## Engine Stall

The potential exists for these engines to stall for no apparent reason. This issue is limited to KOHLER® 7000 Series engines within the serial number range of **45327xxxx through 4613302464**. Not all engines in this serial range will exhibit the condition.

**Figure 1. Cut Existing Evap Line in Half.**

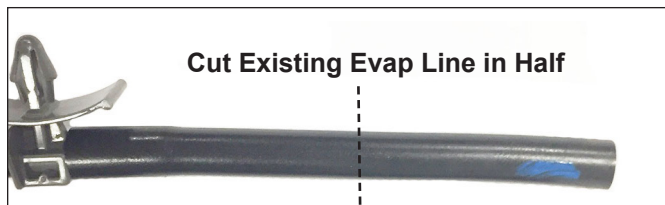
1. To access the evap line, remove the air cleaner cover, air cleaner element, and air cleaner base.
2. Locate the existing evap line (as shown in Figure 1), remove it from the purge port nipple on the carburetor, and cut it in half.

**Figure 2. New T-Fitting and New Line Assembly.**

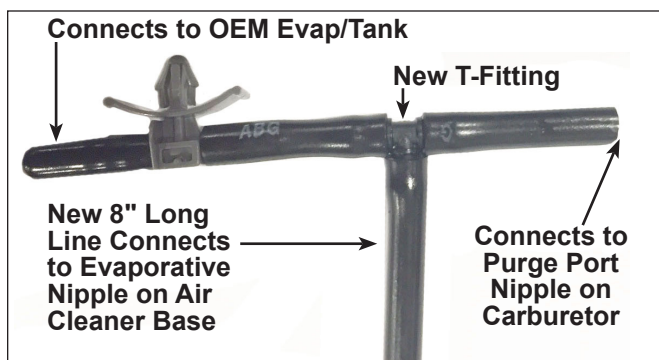
3. Install the new T-Fitting at the location of the cut line. Take the new 25 326 28-S 14" long line and cut it to an 8" length. Install and route the new 8" long line as shown in Figure 2.

**Figure 3. New T-Fitting/Line Assembly Installed.**

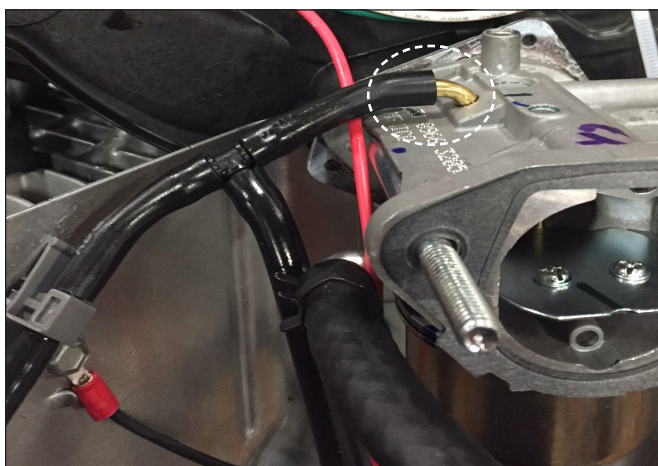
4. New T-Fitting and line assembly is shown installed on the engine in Figure 3.

**Figure 4. Connect New 8" Long Evap Line to Air Cleaner Base.**

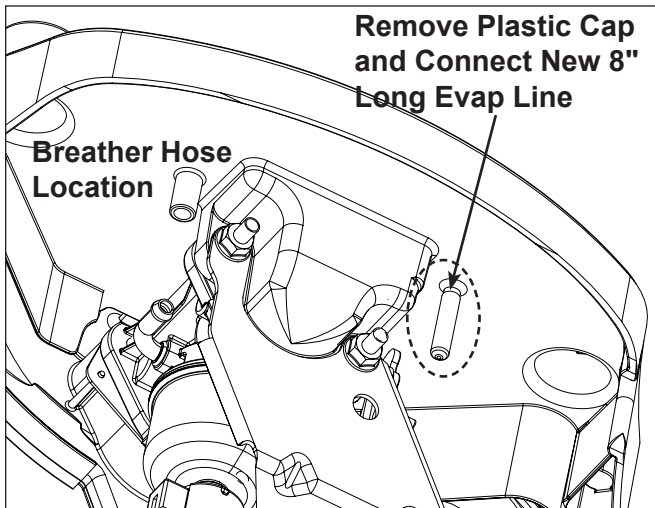
5. Route the new 8" long evap line from the T-Fitting to the plugged port on the air cleaner base. Remove and discard the plastic cap at that location. See Figure 4.
